Project	IEEE 802.16 Broadband Wireless Access Working Group < http://ieee802.org/16 >	
Title	Clean Up section 14.5.6	
Date Submitted	2006-01-05	
Source(s)	Mary Chion Jeff Qian Cancan Huang Sean Cai ZTE San Diego Inc	mchion@ztesandiego.com
Re:	Contribution on comments to IEEE 802.16g-05/008r2	
Abstract	Section clean up for 14.5.6.	
Purpose	Adoption	
Notice	This document has been prepared to assist IEEE 802.16. It is offered as a basis for discussion and is not binding on the contributing individual(s) or organization(s). The material in this document is subject to change in form and content after further study. The contributor(s) reserve(s) the right to add, amend or withdraw material contained herein.	
Release	The contributor grants a free, irrevocable license to the IEEE to incorporate text contained in this contribution, and any modifications thereof, in the creation of an IEEE Standards publication; to copyright in the IEEE's name any IEEE Standards publication even though it may include portions of this contribution; and at the IEEE's sole discretion to permit others to reproduce in whole or in part the resulting IEEE Standards publication. The contributor also acknowledges and

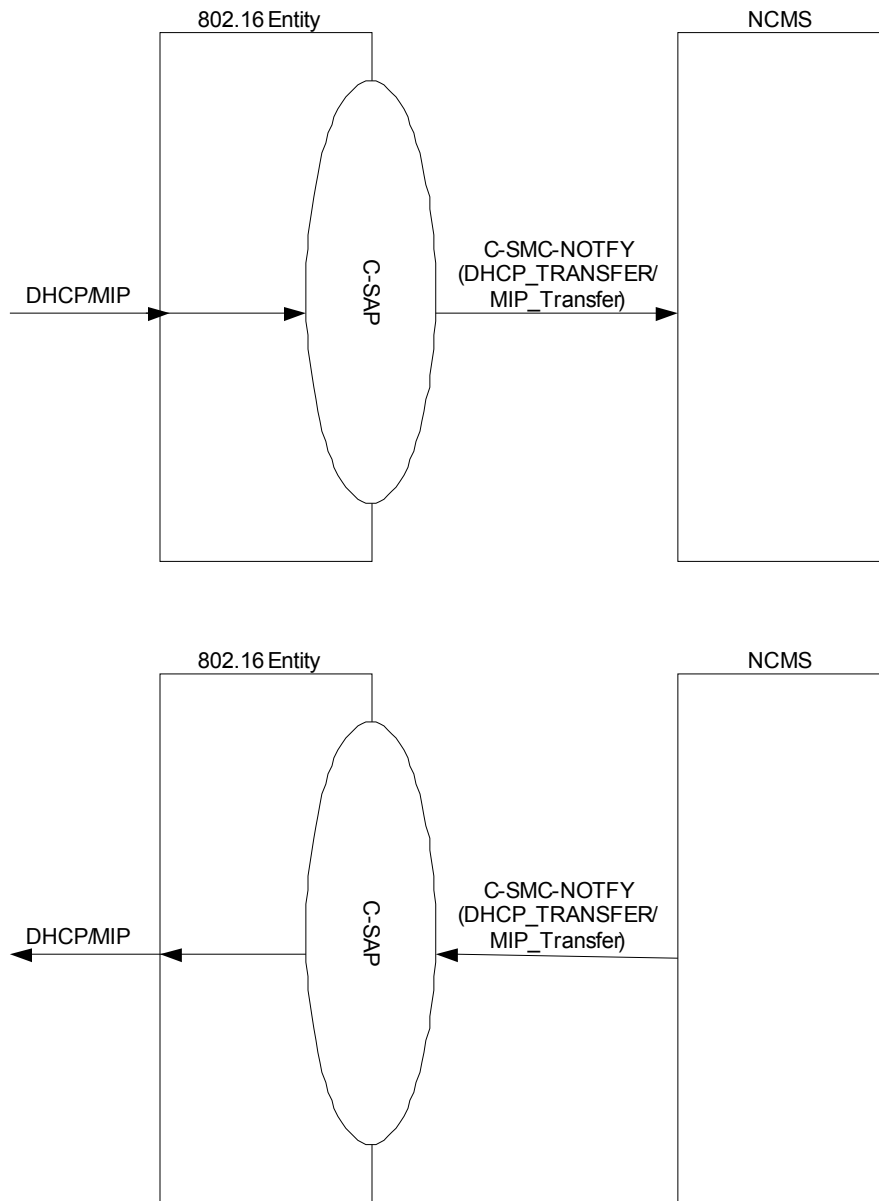
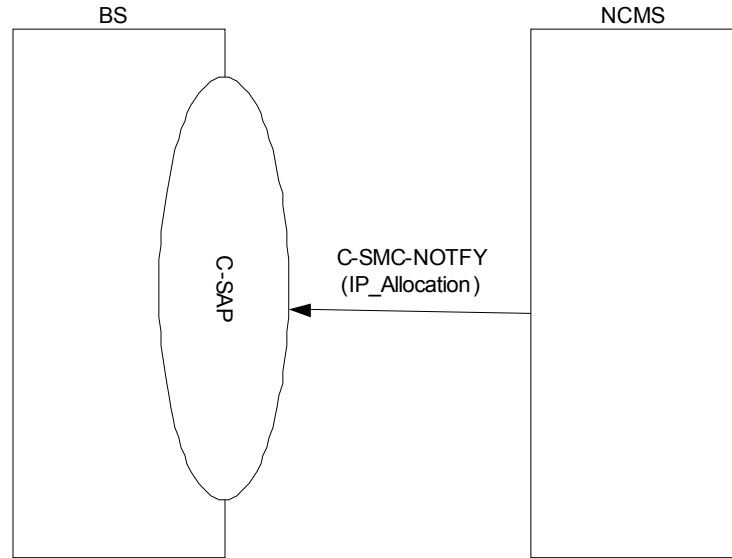
<Note to editor: Service flow provisioning should be part of configuration management which is covered in MIB, recommend removing this section>

Figure 315 C-SFM-REQ(Create) and C-SFM-RSP(Create) primitives flow, 802.16 Entity initiated

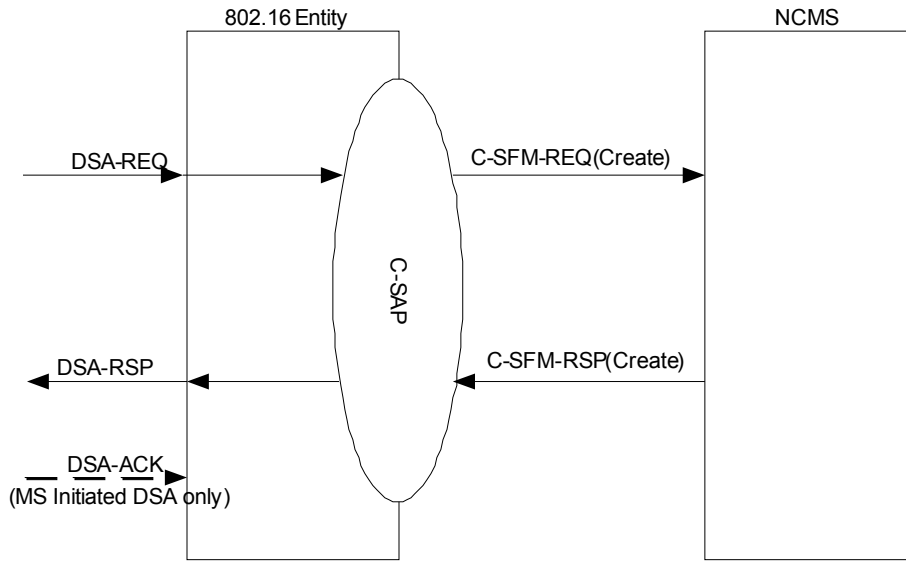
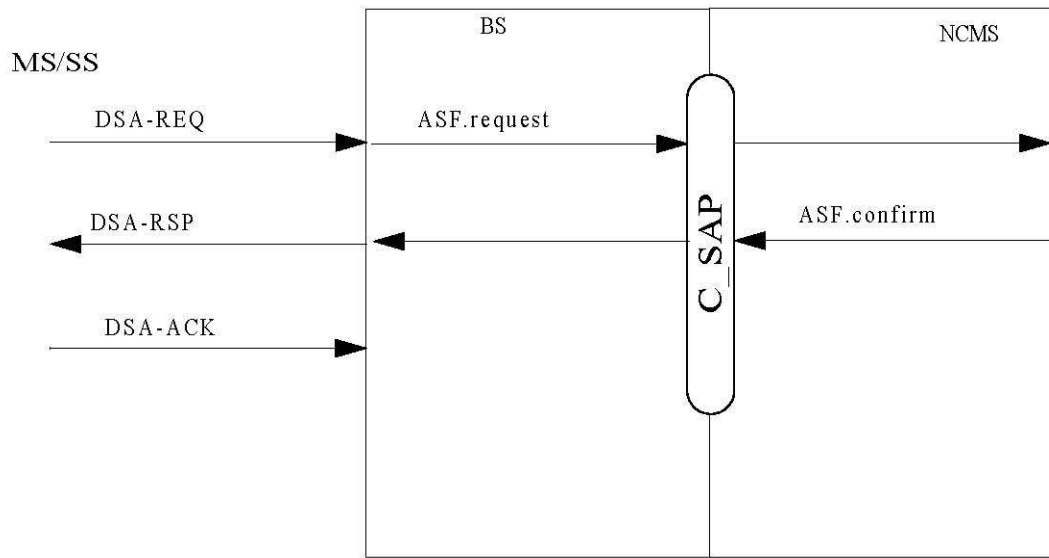
1. Rename Primitives. The following table provides a mapping between the old and new names of the primitives:

Existing Primitives	New Primitives
DHCP_Transfer	C-SMC-NOTFY(Event_type==DHCP_TRANSFER)
MIP_Transfer	C-SMC-NOTFY(Event_type==MIP_TRANSFER)
IP_Allocation_Notification.indication	C-SMC-NOTFY(Event_type==IP_ALLOCATION)
Add_Service_Flow.request (ASF.request)	C-SFM-REQ(Operation_type==CREATE)
Add_Service_Flow.indication (ASF.indication)	C-SFM-REQ(Operation_type==CREATE)
Add_Service_Flow.confirm (ASF.confirm)	C-SFM-RSP(Operation_type==CREATE)

Figure 317 C-SFM-REQ(Set) and C-SFM-RSP(Set) primitives flow, 802.16 Entity initiated

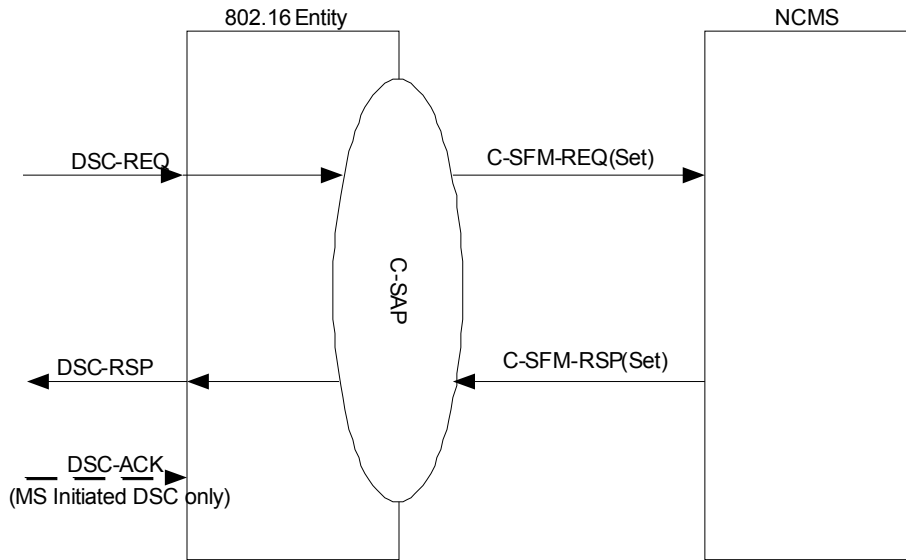
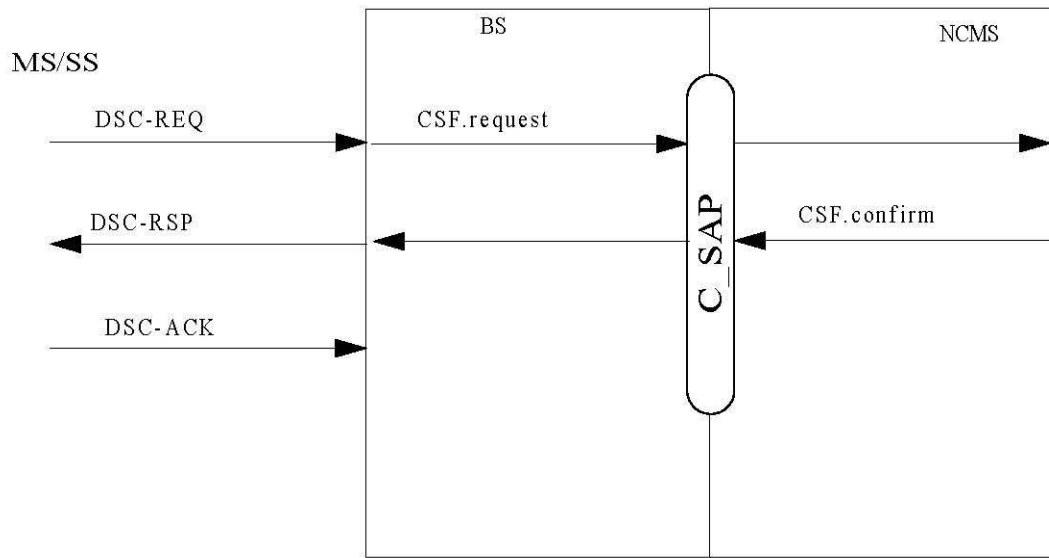
Add_Service_Flow.response (ASF.response)	C-SFM-RSP(Operation_type==CREATE)
Change_Service_Flow.request (CSF.request)	C-SFM-REQ(Operation_type==SET)
Change_Service_Flow.indication (CSF.indication)	C-SFM-REQ(Operation_type==SET)
Change_Service_Flow.confirm (CSF.confirm)	C-SFM-RSP(Operation_type==SET)
Change_Service_Flow.response (CSF.response)	C-SFM-RSP(Operation_type==SET)
Delete_Service_Flow.request (DSF.request)	C-SFM-REQ(Operation_type==DELETE)
Delete_Service_Flow.indication (DSF.indication)	C-SFM-REQ(Operation_type==DELETE)
Delete_Service_Flow.confirm (DSF.confirm)	C-SFM-RSP(Operation_type==DELETE)
Delete_Service_Flow.response (DSF.response)	C-SFM-RSP(Operation_type==DELETE)
